**SUBJECT:** AB 617 BARCT Analysis for Reciprocating Internal Combustion Engines

**DRAFT  
Assembly Bill 617 –  
BARCT Analysis for Reciprocating Internal Combustion Engines**

### 7.1 Attachment #1. Industry Comments and Responses

**Figure 1.2 – Stoichiometry and the Effect of Air/Fuel Ratio on Pollutants**

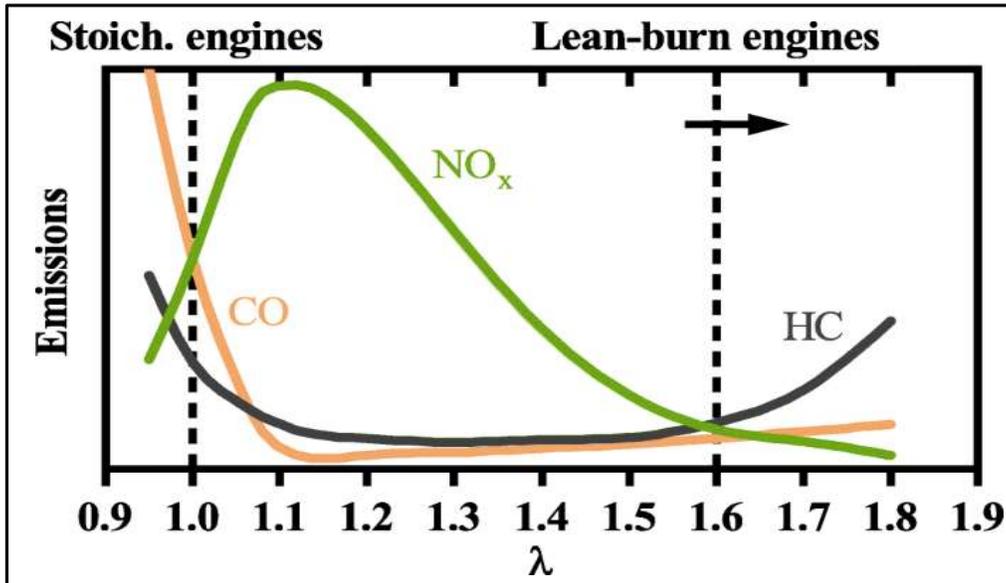
#	Section	Comment	District Response
1)	1.2	Is there a scale for the Y axis? <i>[In regard to Figure 1.2 – Stoichiometry and the Effect of Air/Fuel Ratio on Pollutants]</i>	Figure 1.2 does not have a specific scale that addresses all 3 pollutants (NOx, CO, and total hydrocarbons). The Y-axis is used to show the approximate change in emission concentration for each of the pollutants as a 4-stroke natural gas engine operates between stoichiometric and lean-burn conditions.
